AMENDMENTS TO THE DRAWINGS

REMARKS / ARGUMENTS

The present Amendment is in response to the Office Action mailed December 23, 2005. The Office Action indicated that claims 1-31 were pending in the application. Applicant respectfully brings to the Examiner's attention that the present patent application was filed with 40 claims. Applicant paid the additional fees for these claims. There have been no other substantive actions. Therefore, the application presently had claims 1-40 pending.

FIG. 12

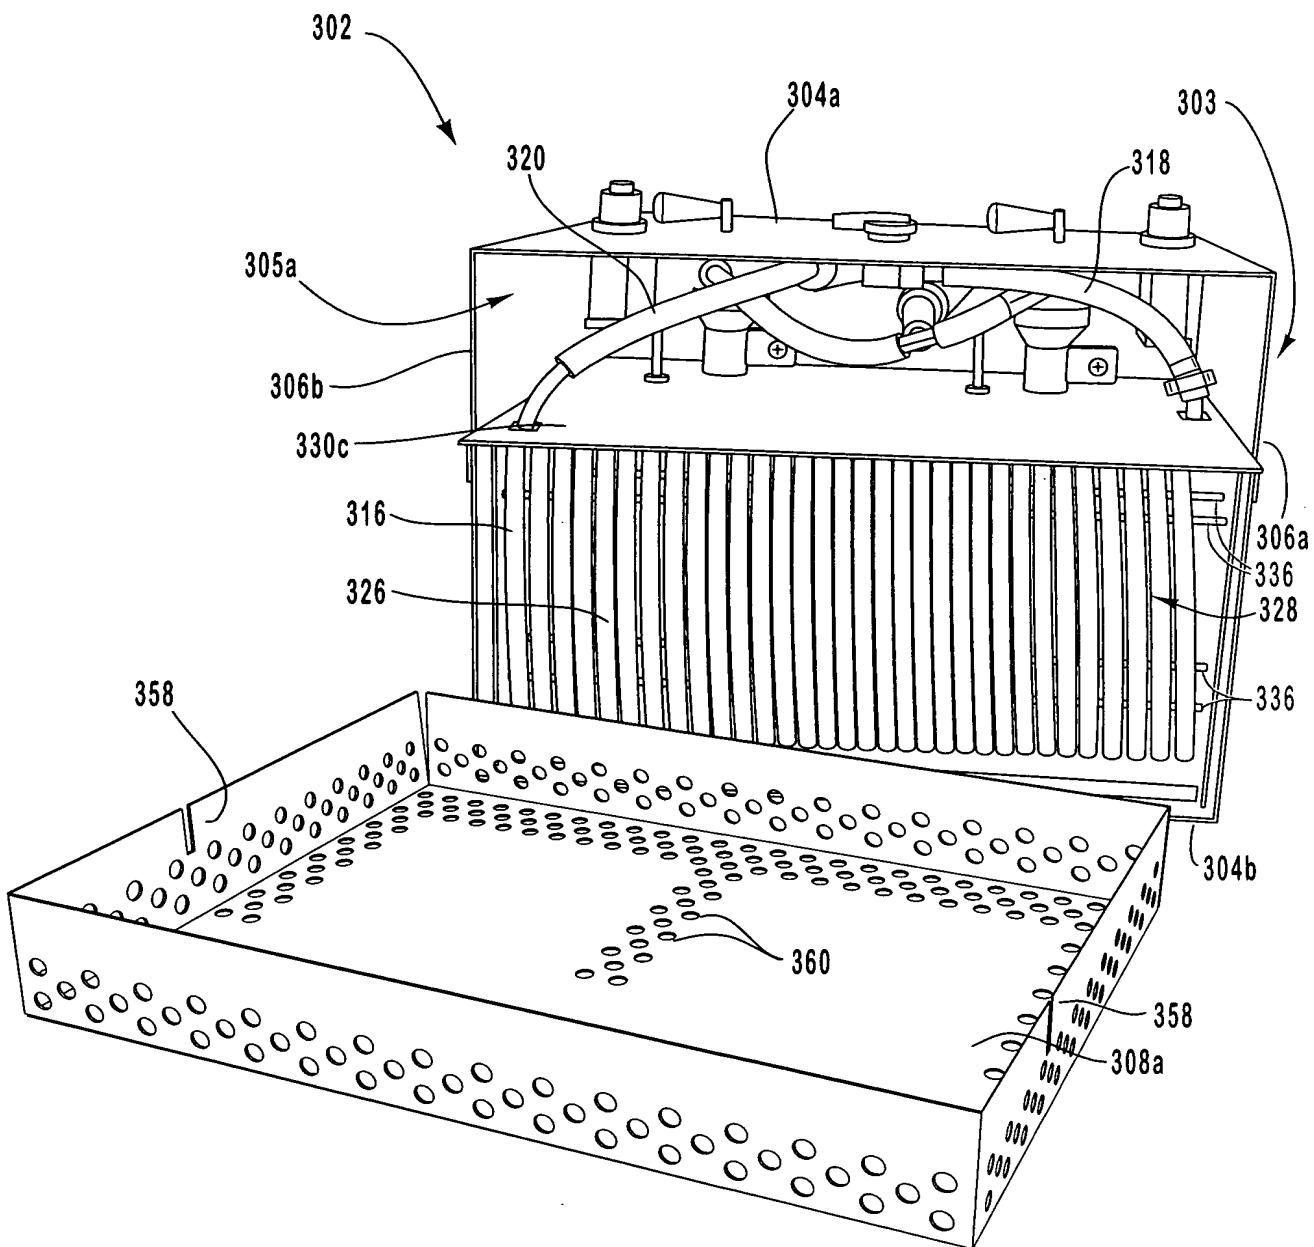
The attached sheets of drawings include changes to Figures 12 and 13. These sheets replace the previous sheets, including Figures 12 and 13, submitted with the Response to the Notice to File Missing Parts filed November 10, 2004. Figures 12 and 13 now include reference character 336 inadvertently left off. No new matter is added by Figures 12 and 13, which is supported in the specification as originally filed.

In the Office Action, the Examiner objected to the drawings under 37 C.F.R. § 1.84(p)(5) as not including a reference sign for support rods 336 mentioned in the description. Applicant respectfully submits that the support rods 336 are shown in Figure 13 of sheet 12 of the annotated sheets filed November 10, 2004, but the reference character was inadvertently left off of the Replacement Sheet filed the same day. For clarity, reference character 336 has also been added to Figure 12.

Accordingly, Applicant has revised Figures 12 and 13 to include the reference character 336, as discussed above in the "AMENDMENTS TO THE DRAWINGS" section of this response. Applicant respectfully requests withdrawal of the objection to the drawings.
